1431 FRANKLIN STREET

Office Entitlement - Response to Design Review Analysis
11/09/2021

RESPONSES TO DESIGN REVIEW ANALYSIS

ARCHITECT'S ANSWERS TO NON-COMPLIANT AND UNCLEAR LINE ITEMS

LINE 88

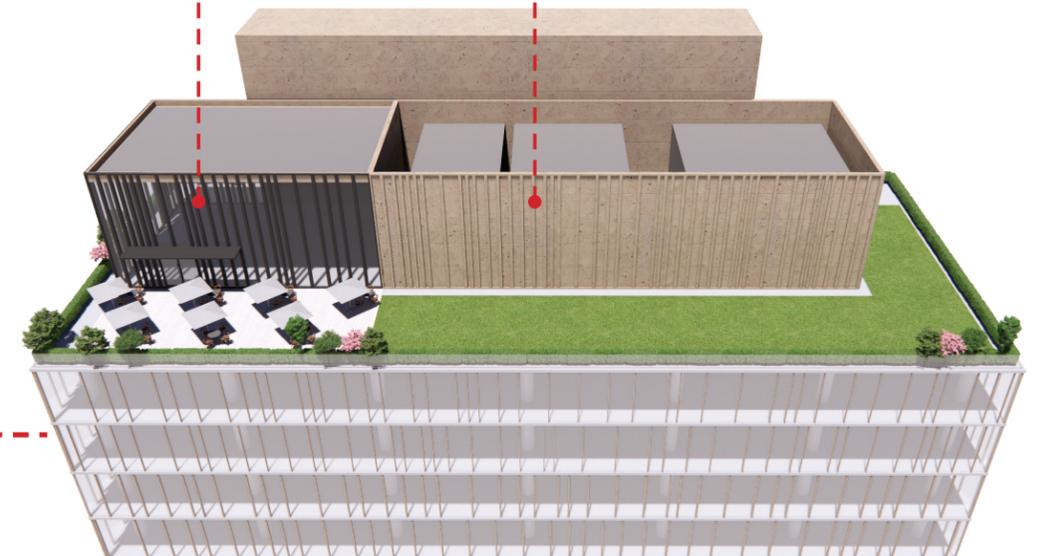
The proposed green space concept on the roof does not supply details on proposed materials, roof line decoration or design, or floor plan.

Section 5.4.2 continues to on to say, 'Rooflines should have shapes, materials, and colors that relate to the rest of the building, while still being differentiated to achieve an upper terminus.' Though I understand where this logic comes from, I would also note that in the Oakland guidelines they go on to say, 'In general, each applicable guideline should be met to approve a development proposal. However, this document is not intended to restrict innovation, imagination and variety in design.' Providing a roofline that differentiates to achieve an upper terminus really applies to a mid-century modern highrise but not necessarily to all buildings of today. Which is why our solution for the proposed project is based more in a non-classical building terminus. In other words, instead of the building having a cornice or capital like a classical column the design of many buildings today are pattern or volume oriented. In fact, some almost do the opposite, with the top fading away to less than what it was. Below are a couple examples of both directions. That is not to say a building with a cornice is the wrong direction, we are simply noting that the guideline stated here is a recommendation that should be viewed as one option.

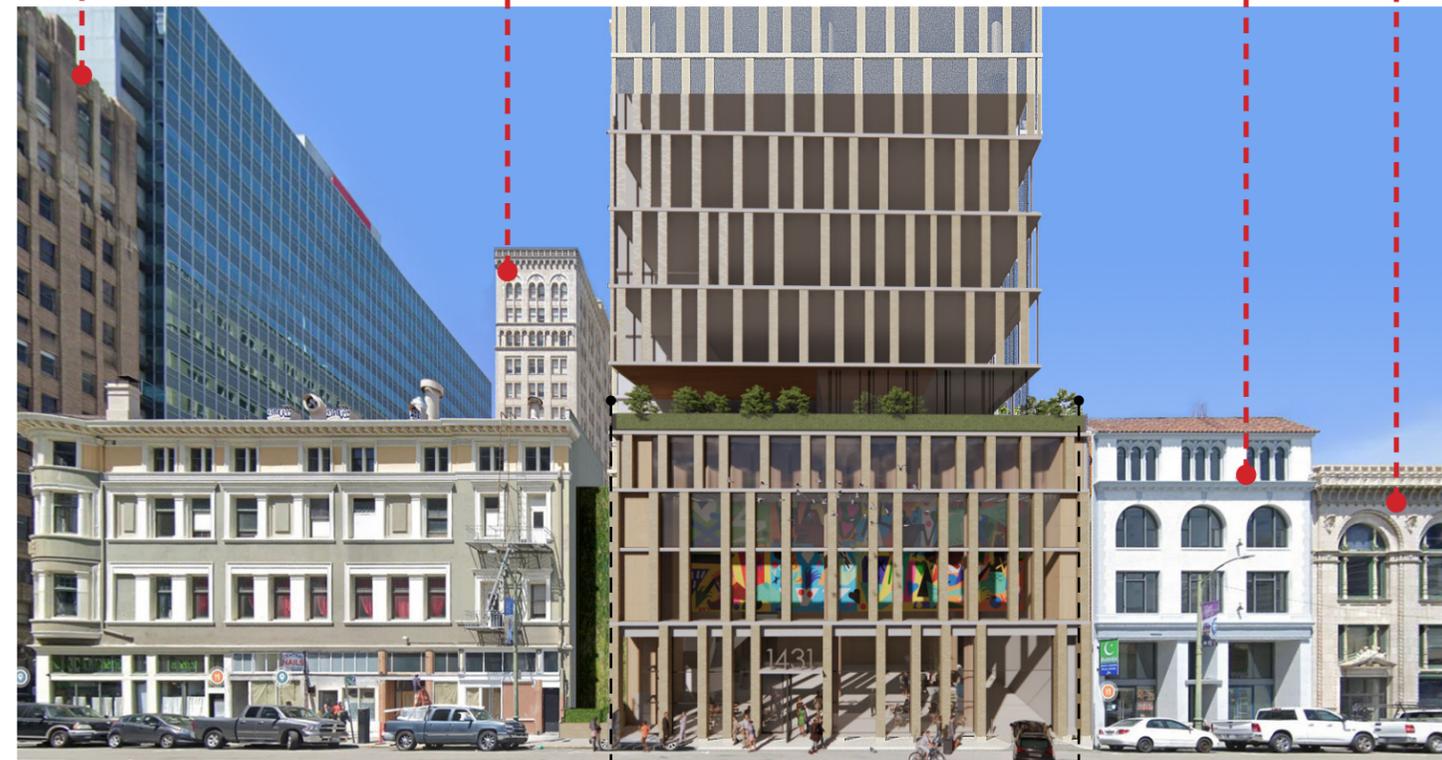
The proposed base of the tower does not conform to the API in rhythm, composition, or patterns of openings. More details must be provided on the ground floor lobby.

The base of the building has been redesigned to better reflect the widths and rhythm of the facades on the street, and entrances that reflect the patterns on the street. As previously noted, the revised design of the proposed building has a strong relationship to the adjacent buildings in terms of massing and, it's modern interpretation to the predominately classical horizontal layer that exists in the Historic district. The pattern of windows also mimics the window layout of the adjacent buildings in a modern way. In addition, the base of the proposed building will have a traditional brick base to pick up on the similar use of materials that are prevalent on the adjacent buildings in the Historic District. In addition, we have located key cornice lines to match the adjacent buildings. But it is worth noting that the cornice lines of the two adjacent buildings are not at the same height or size. With this in mind, we elected to split the difference and make for a compromise geometry that is intended to be visually as cohesive as possible.

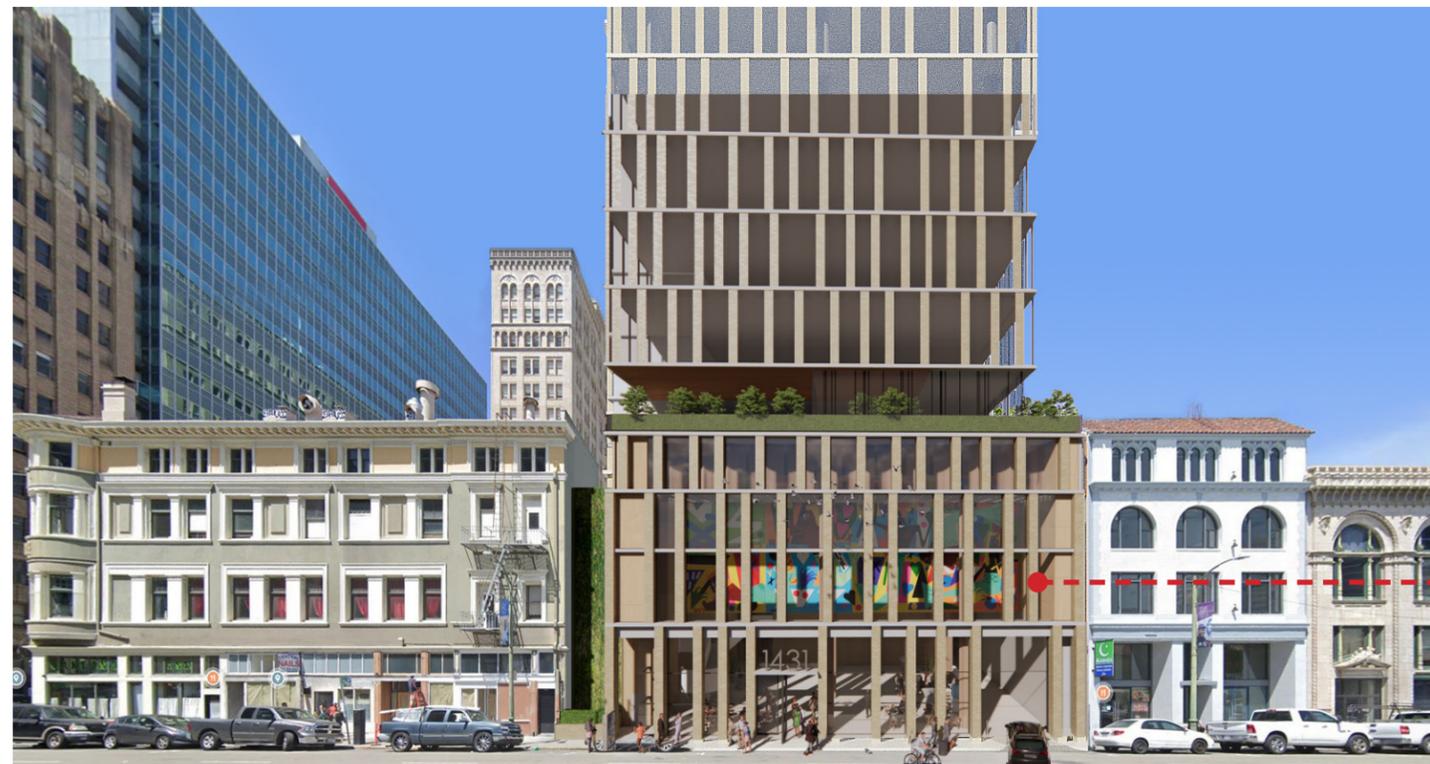
The proposal does not reflect the level and quality of visual interest of the API contributors or otherwise enhance the visual interest of the API. More details of composition, materials and projection are needed

The proposed design is not a historic replication of some of the older revivalist buildings in the area, nor is it a reinterpretation of some of the modern buildings. In general, the Historic district is most notable for its overall content. Across the road from the proposed project is not part of the historic district. The actual site itself is a parking lot and does not contribute to any historic district. The new proposal is like some of the modern Highrise buildings in the area, but instead of using only glass and metal at the base of the tower, the proposal uses finishes and materials in the style of the historic older buildings. The use of brick at the base of the building up to the 55-foot level is a deliberate design consideration to blend a modern building into the API. The proposed design has also brought across many of the proportions and rhythms of the historic buildings. The proposed project is not a literal interpretation of the historic buildings in the API, but unlike any of the other modern buildings in the entire downtown district of Oakland, the proposed design has been carefully crafted to keep many of the proportions and materials like the existing buildings. The datum lines have been brought across the façade unlike any other modern building in the area, and the use of brick at the base is unlike any other modern building in the area.
